**Revised Draft Remedial Action Plan  
and Site Design for Stabilization of  
Moab Title I Uranium Mill Tailings  
at the Crescent Junction, Utah,  
Disposal Site**

**Remedial Action Selection Report**

**June 2007**

Figure 5-1. UMTRA Project Cover Design and Alternative Cover Design

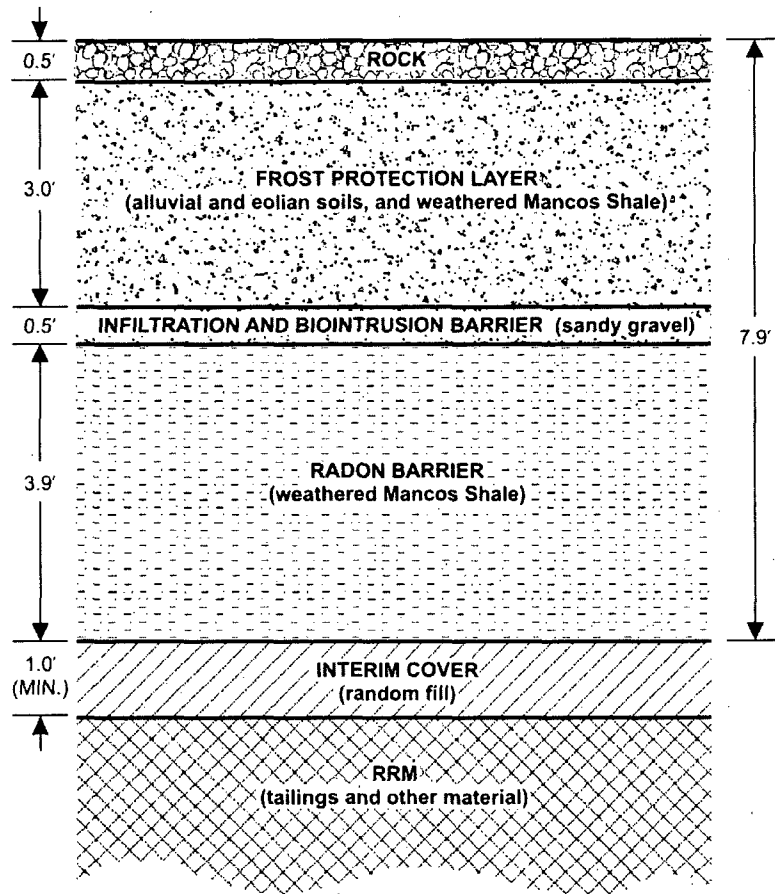
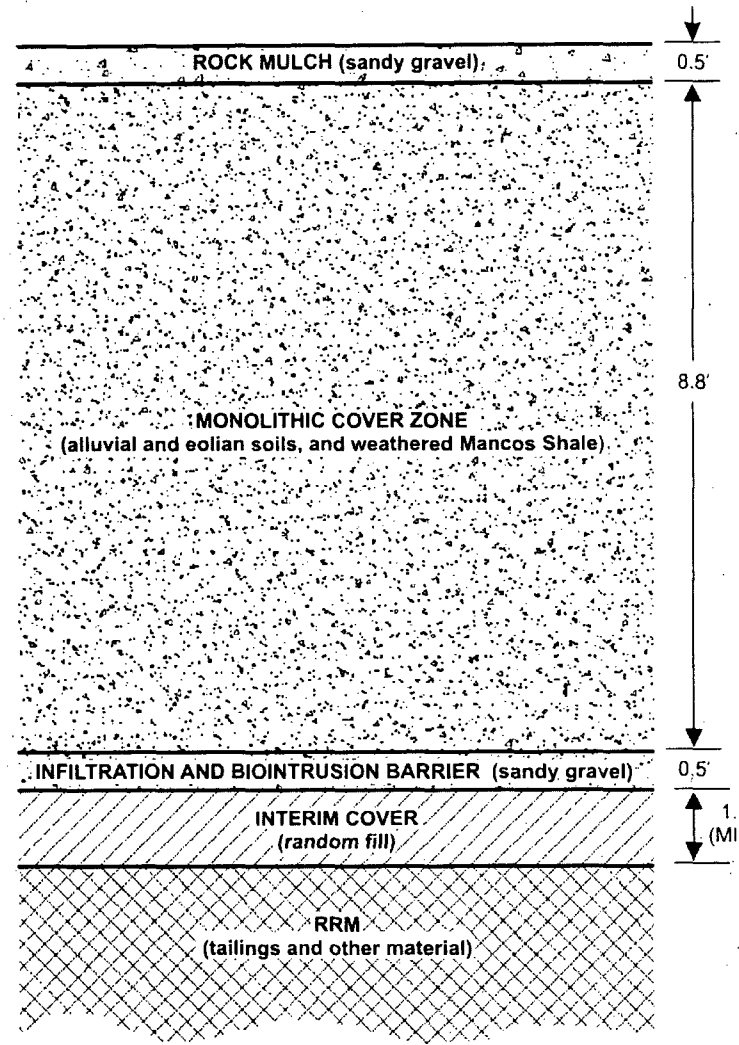
**GT8. Cover Design:** In Section 5.0 and Figure 5-1, DOE discusses and portrays two different cover alternatives, but does not indicate which is planned or preferred. Provide a discussion on the factors that will determine which of the two covers will be used.

Figure 7-2. Disposal Cell Layout with Typical Cross-Section Locations

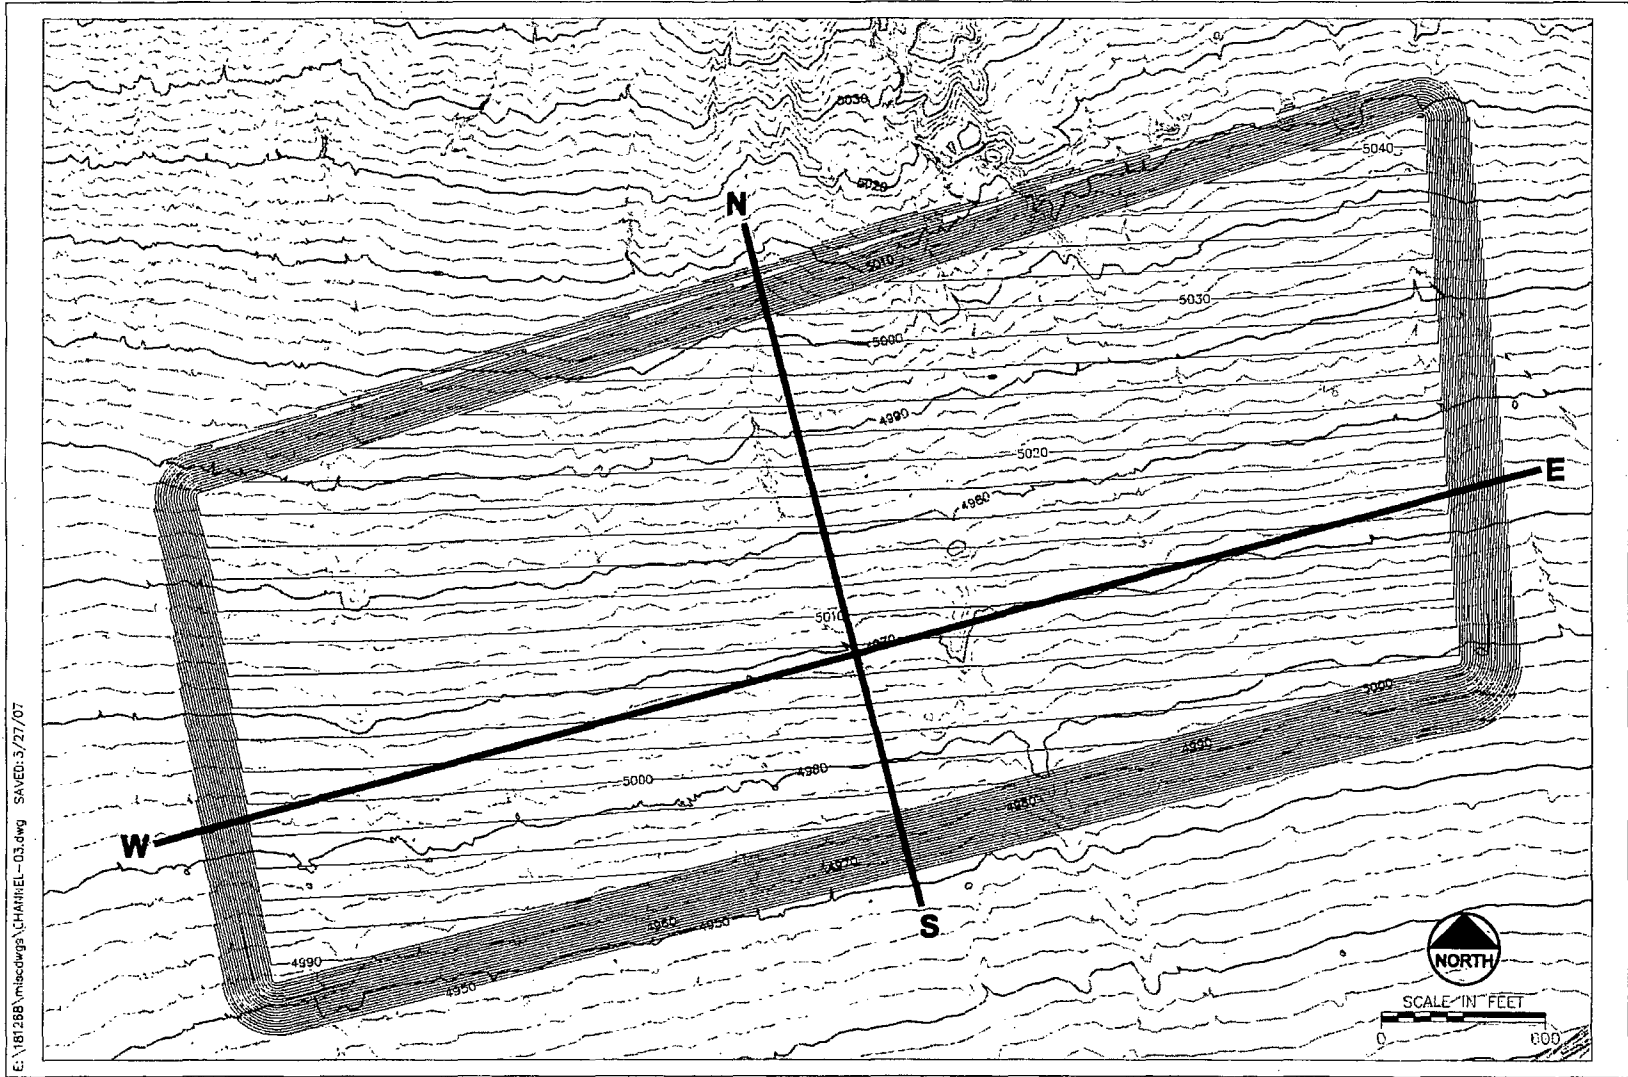
RASR, page 4-3, section 4.1.2. Text in this section indicates "the disposal cell excavation is anticipated to be into the Quaternary materials, as well as into upper portions of the weathered and fractured Mancos Shale." On page 7-1, section 7.0, the text indicates the anticipated depth of excavation is 15 to 20 feet (ft). Figure 7-2 shows the excavation limits as approximately 10 ft below bedrock. Figure 7-3 shows the cell directly on the weathered Mancos Shale contact. It is unclear how far the cell will be placed into the Quaternary alluvial material and/or the weathered and fractured shale. Will the top several feet of weathered shale be removed or will the cell be placed directly on the first contact of the weathered Mancos Shale? The depth of the cell and what material the cell will be placed on should be clearly stated and consistent throughout the Report.

A revised Figure 7-2, a new Figure 7-3, and a revised Figure 7-4 have been inserted into Section 7.0 of the RAS.

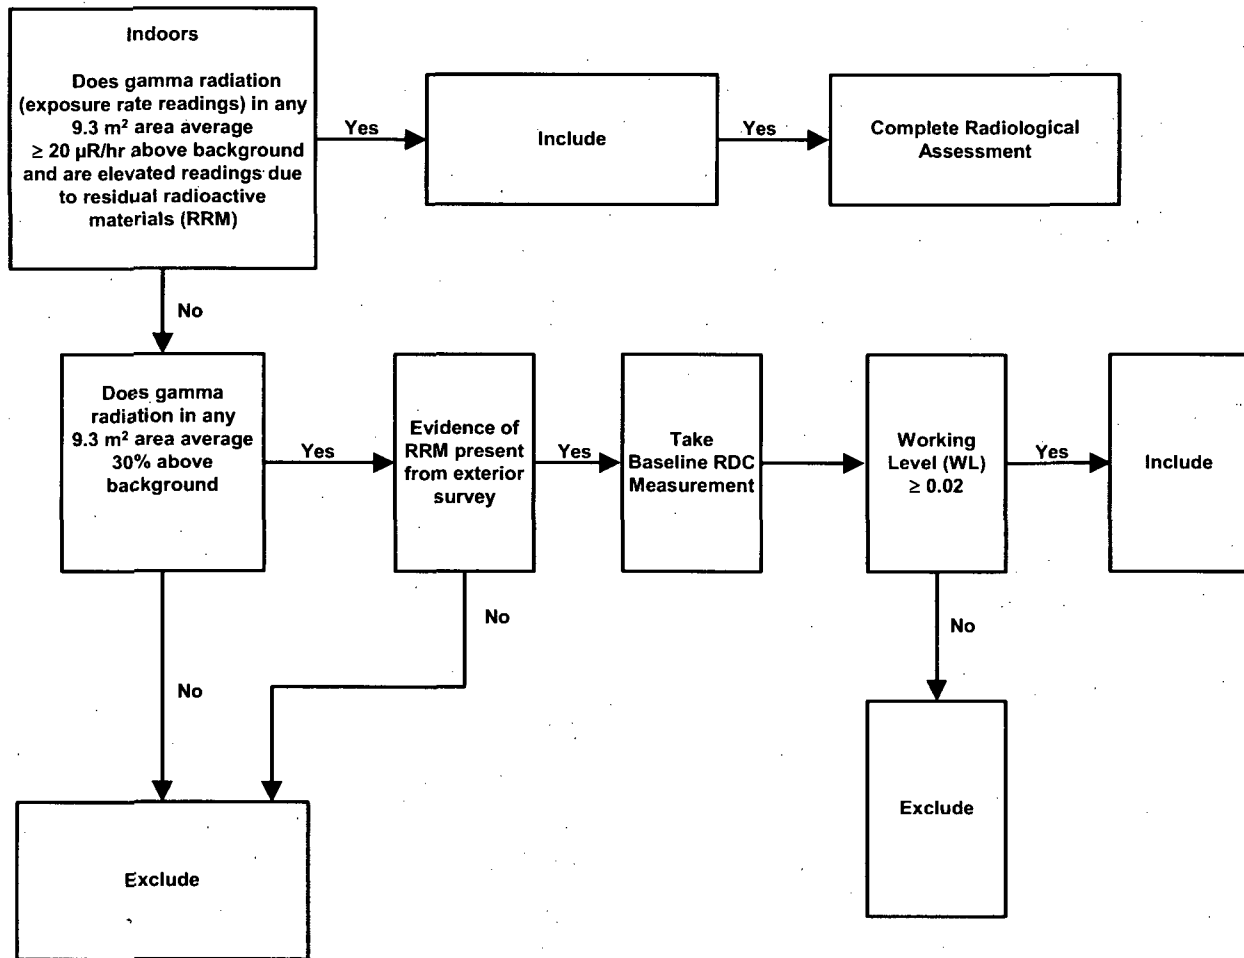
- R2.** Please provide more detail on which areas will require supplemental standards and the justification for use of supplemental standards on these areas.

DOE is currently considering the use of supplemental standards on several areas on the millsite, Policaro vicinity property, and BLM properties surrounding the millsite. Examples of where DOE does not plan to remediate include: contamination under the highway asphalt; contamination around high-pressure natural gas lines and buried electric and fiber optic lines; and contamination on steep slopes where access is not feasible and cleanup would cause excessive environmental damage.

DOE understands that additional information is required to substantiate the application. Depending on which provision of 40 CFR 192.22 is cited, the following minimum information is provided:
